Subject: Submittal of DP-63 VCM Work Plan Addendum Memorandum, Holloman
AFB, NM

ADDENDUM FOR ADDITIONAL INVESTIGATION REQUIREMENTS WORK PLAN ERP SITE DP-63 (AOC-3) Ammunitions Disposal Pit HOLLOMAN AFB, NEW MEXICO

Subject: MODIFICATION TO SEPTEMBER 2006 DP-63 VOLUNTARY
CORRECTIVE MEASURES WORK PLAN OF SEPTEMBER 2006.

DP-63 North Pit

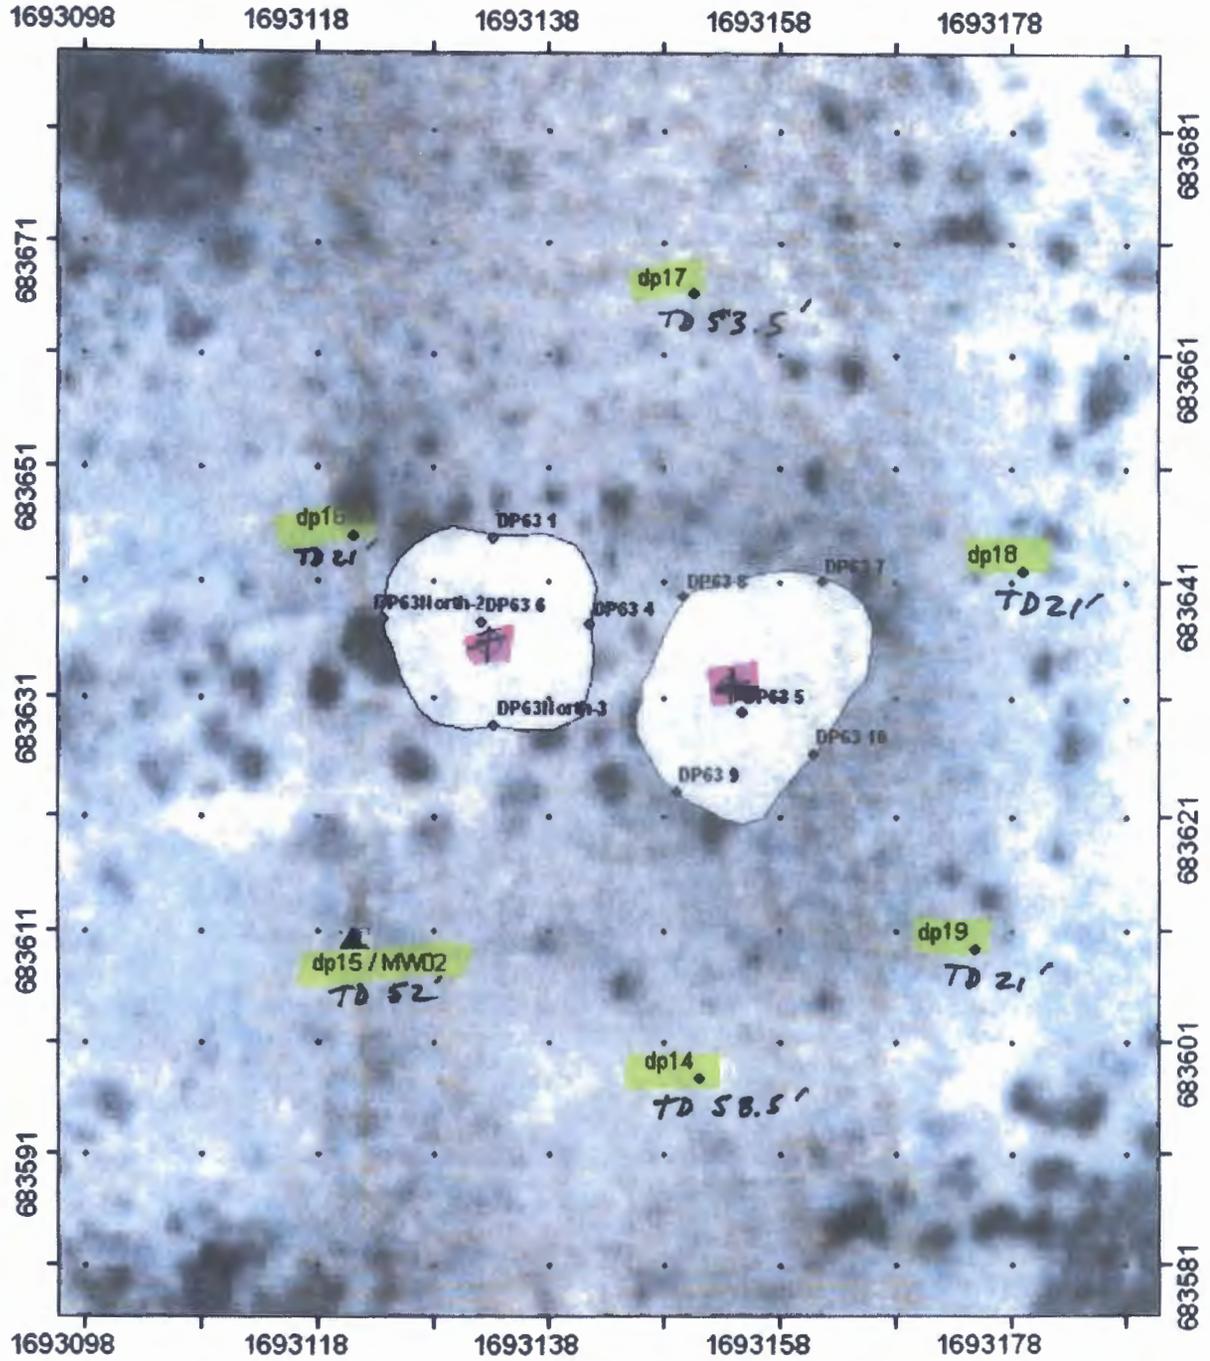
1. Moving these borings/monitoring wells to the center of each pit to provide vertical delineation.
2. Submit more soil samples (3 each) from each boring for laboratory analysis to provide better vertical delineation.
3. Converting more borings to groundwater monitoring wells (a total of 5 instead of 3).

The DP-63 munitions and explosives of concern excavations were completed in September 2006. The boundaries of the North, East and West disposal pits were significantly smaller than anticipated in the DP-63 VCM work Plan. A revised scope of work has been developed to reflect the actual pit boundaries. The proposed scope of work includes drilling 50 foot bgs boreholes (to the groundwater table) through the center of each of the four defined disposal pits (two small pits in the North, the East pit and the West pit). The surveyed outlines of the actual pits and the new boring locations are illustrated on the revised maps of the North, West and East pits. These maps are presented as **Attachments 3**,

-  Previous investigation borehole and MW loc
-  Proposed bore hole/mw location
